RE: **Coors Blvd Wecks**
730 Coors Blvd NW
Grading and Drainage Plan
Engineer's Stamp Date: 2/28/19
Hydrology File: J11D032

PO Box 1293
Based on the submittal received on 3/5/19, the Grading and Drainage Plan is approved for Site Plan for Building Permit (Administrative Amendment) and Building Permit.

C-201

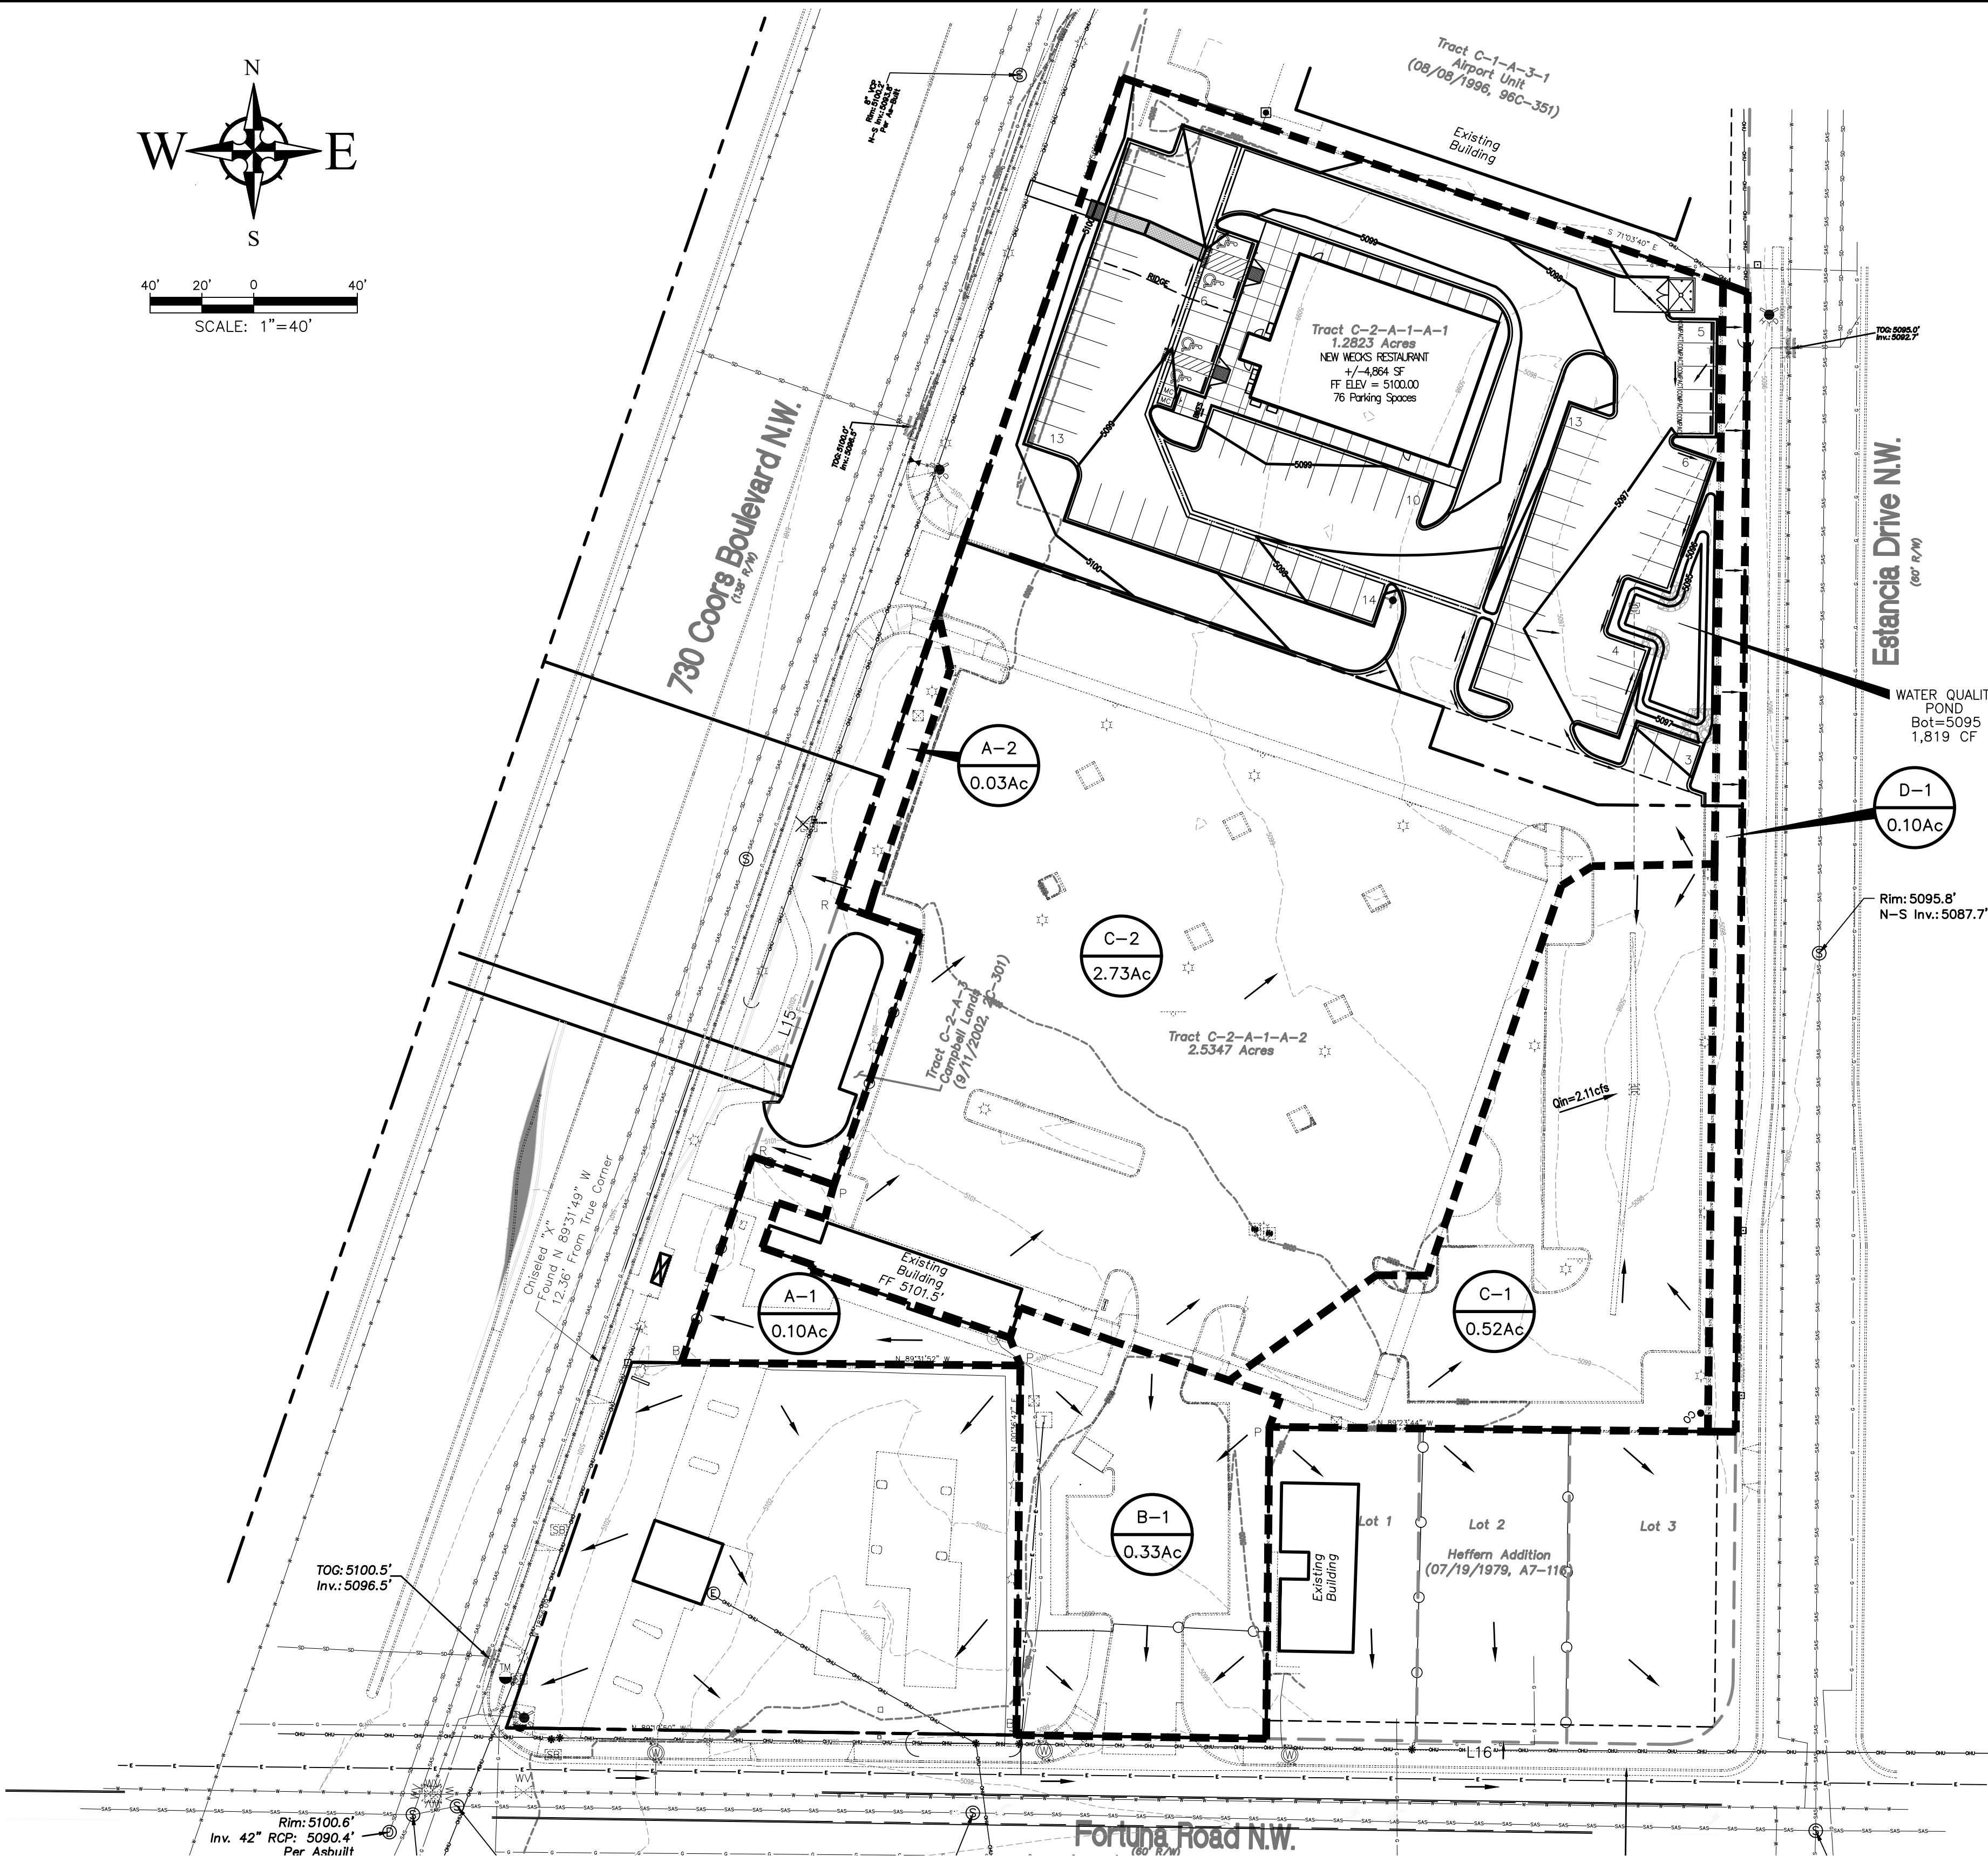
- NM 87103
1. Engineer's Certification, per the DPM Chapter 22.7: *Engineer's Certification Checklist For Non-Subdivision* is required.
 2. A Bernalillo County Recorded [Private Facility Drainage Covenant](#) is required for the stormwater quality pond. The original notarized form, exhibit A (legible on 8.5x11 paper), and recording fee (\$25, payable to Bernalillo County) must be turned into DRC (4th, Plaza del Sol) for routing. Please contact Charlotte LaBadie (clabadie@cabq.gov, 924-3996) or Madeline Carruthers (mtafoya@cabq.gov, 924-3997) regarding the routing and recording process for covenants. The routing and recording process for covenants can take a month or longer; Hydrology recommends beginning this process as soon as possible as to not delay approval for certificate of occupancy.
